## SHENZHEN FENDA TECHNOLOGY CO., LTD.

### Declaration of Product Modifications

This is to request a Class II permissive change for FCC ID: HBOPA2322 originally granted on 12/22/2022.

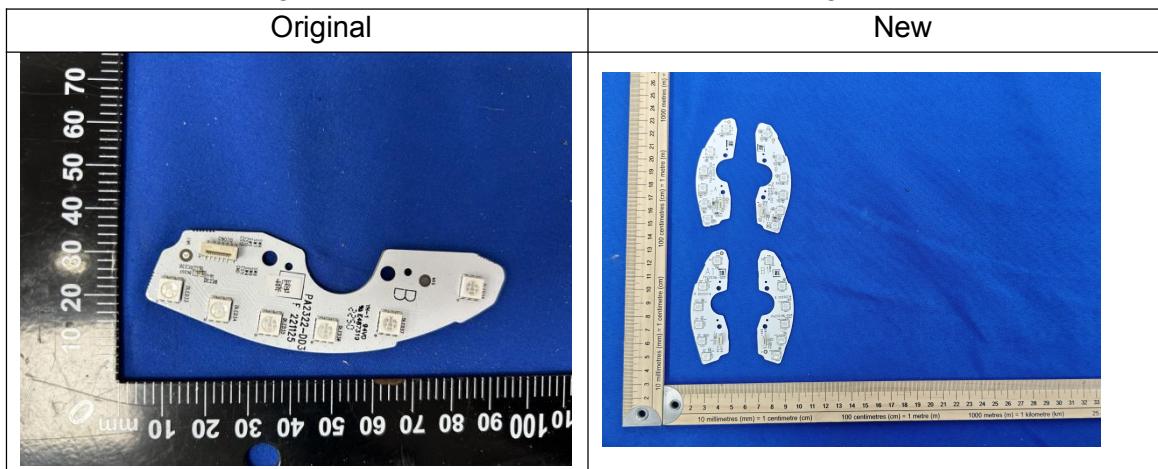
Change #1: The motherboard is different: mainly the IO interface and the interface of the light board have been modified.

#2: The light boards are different. The light driver chips have been removed, and all the 6-pin RGB lights have been replaced with 4-pin RGB lights with self-driver chips.
